ADDENDUM NO. 2

PROPOSAL FOR FURNISHING ALL LABOR, MATERIALS, EQUIPMENT, TRANSPORTATION, SUPERVISION, PERMITS, ETC. NECESSARY FOR THE NIRC-BUILDING 4 (56D) FINISH-OUT, LOCATED AT THE UNIVERSITY OF LOUISIANA AT LAFAYETTE CAMPUS, IN NEW IBERIA, LOUISIANA.

SOLICITATION FILE NO.: 26208 / R1629503 BID DUE DATE/TIME: 03/31/26 @ 2:00 PM
 BID FILE TITLE: NIRC - Building 4 (56D) FINISH OUT
 PRE-BID MEETING HELD: Thursday, 03/06/26 at 9:00 AM LOCATION: NIRC - Building 34 Auditorium
 FACILITATED/CONDUCTED BY: Glenn Oliva (Facilities Management), and Purchasing Department

NIRC - Building 4 Finish Out
Addendum No. 2 - Attachment No. 2

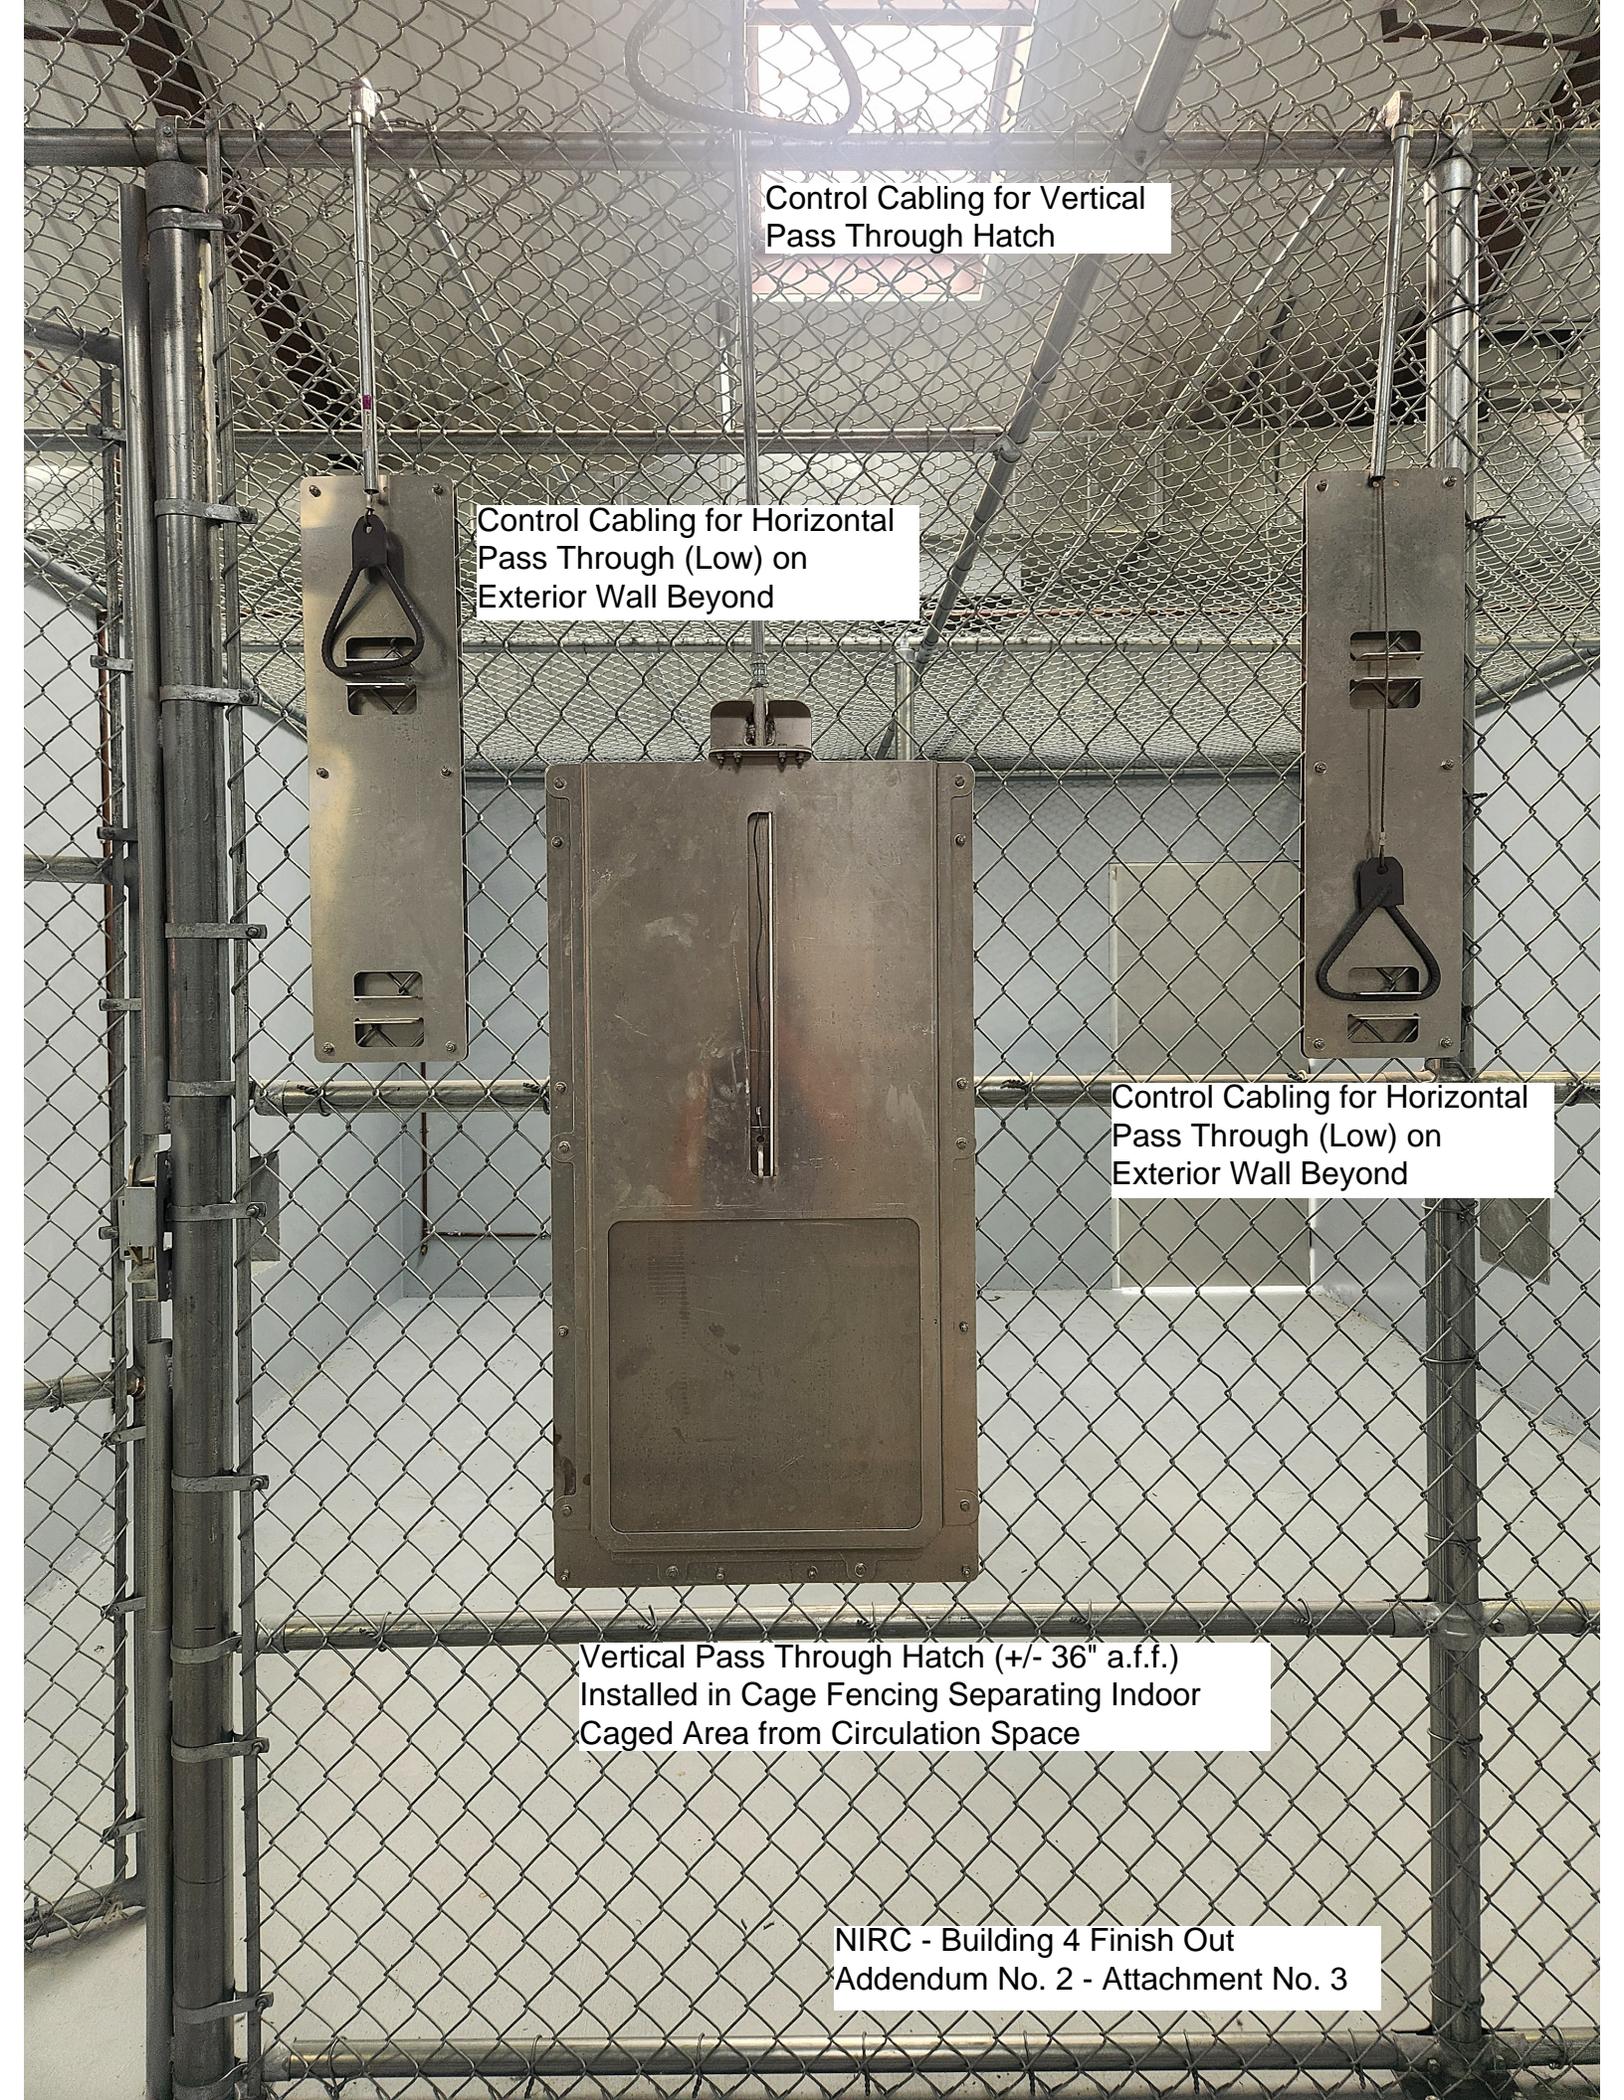
6. **Drawing Sht A3.2:** As clarification, delete the note on Sheet A3.2 referencing "Owner-provided pass-through doors". Pass-through doors shall be provided and installed by the Contractor. The associated access control, cabling and piping, pulls, etc for the access and pass through doors are to be provided and installed by the Contractor. **See Attachments No. 2, 3, 4, 5.**

16. **Question** – A “Chute Door Assembly” is detailed on sheet A2.5 It is a horizontal sliding door assembly. Is this to be used in the locations indicated “pass through” on the same drawing? The pass through doors on the existing building (56A) appear to be a different design (vertical sliding).

Response – The horizontal pass through (low) sliding door assembly shown on drawing sheet A2.5 is to be installed on the concrete wall that separates the inside caged areas from the outdoor caged areas with controls installed in the Circulation space that traverses the length of the building. There is also a vertical pass through (+/- 36” a.f.f.) hatch type sliding door required to be installed in the cage fencing that separates the indoor caged areas from the Circulation space, with manual controls installed in the Circulation space. All detailing of these pass throughs, including backing materials, piping, cabling, pullies, and handles are to match the existing pass through details as installed in existing buildings 56A, 56B, and 56C. **See attached photos for clarification.**

NIRC - Building 4 Finish Out
 Addendum No. 2 - Attachment No. 9

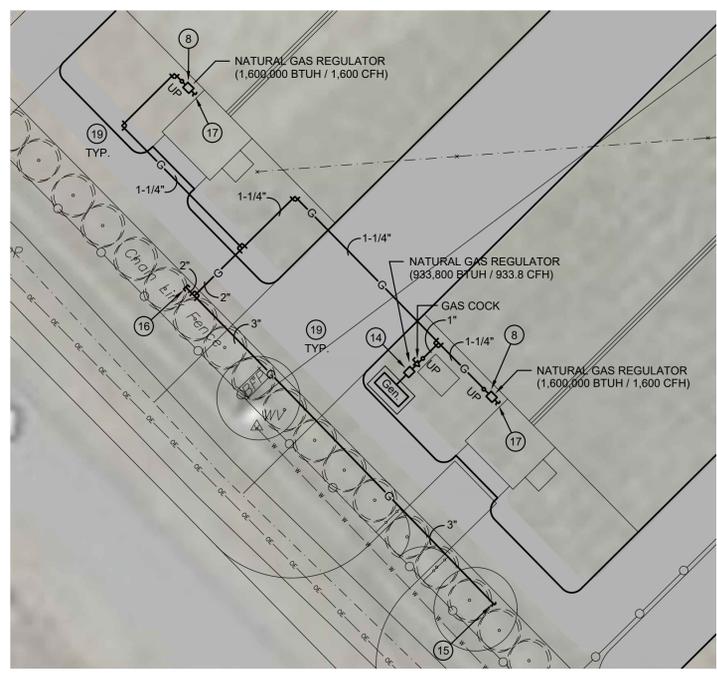
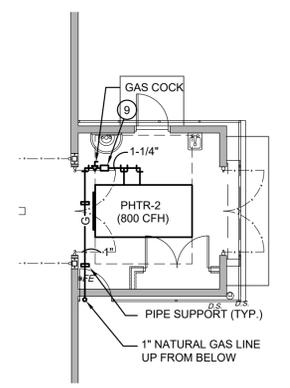
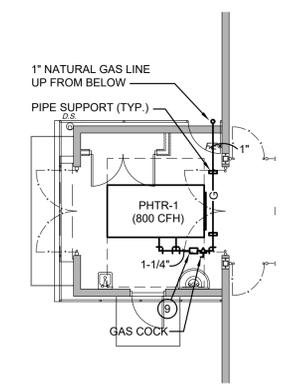
7. **Drawing Sht P2.1:** Delete the previously issued plumbing sheet P2.1 and replace it with the revised plumbing sheet P2.1R. Revisions include relocated routing of “Lix-It” water piping and connections and associated domestic cold water piping. **See Attachment No. 9.**

15. **Question** – The height of the Lixit waterers in the existing buildings are approximately 12” above the finished floor with a piece of aluminum angle bolted to the wall above them. We were told in the job walk that the new building would have them higher on the wall (which would be included in scope if they are above 24’). Also, the location in plan view appeared to be further away from the front of the caged area than shown on the drawings.

Response – See Revised Plumbing Sheets P2.1R and P4.1R. Note that the aluminum angle is not required.

NIRC - Building 4 Finish Out
 Addendum No. 2 - Attachment No. 10

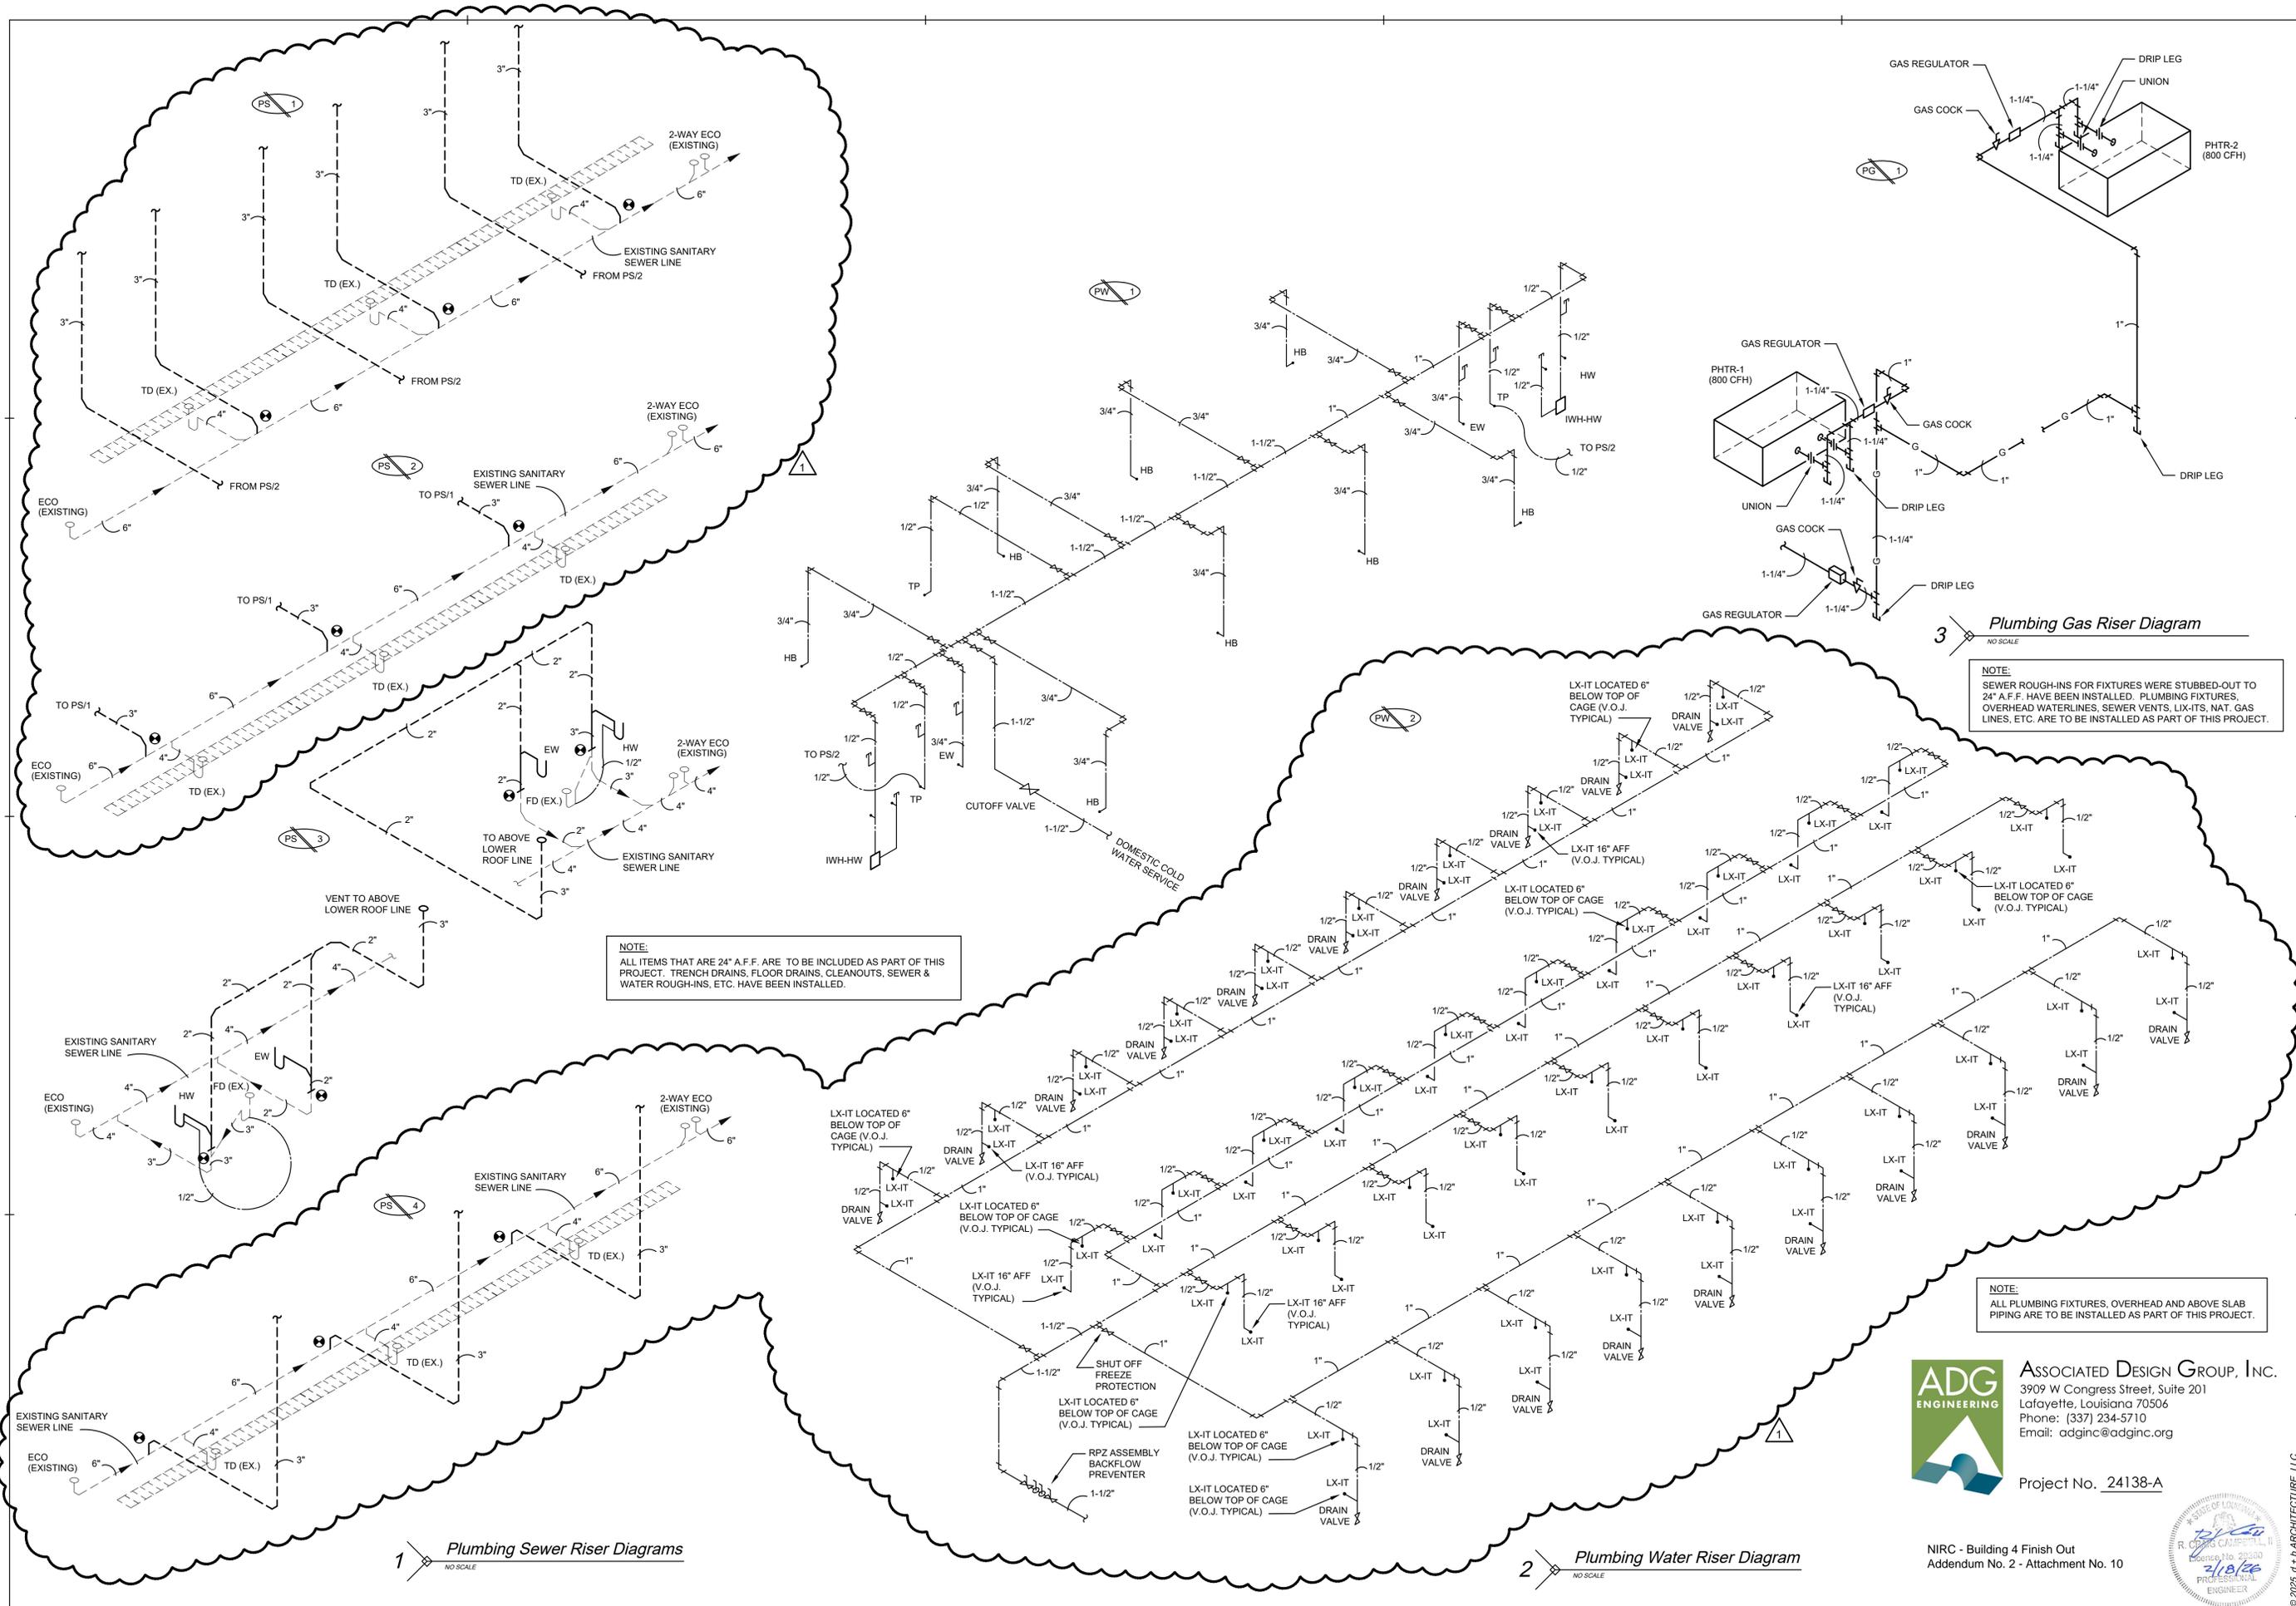
8. **Drawing Sht P4.1:** Delete the previously issued plumbing sheet P4.1 and replace it with the revised plumbing sheet P4.1R. Revisions include the relocated routing of “Lix-It” water connections and associated domestic cold water piping. **See Attachment No. 10.**
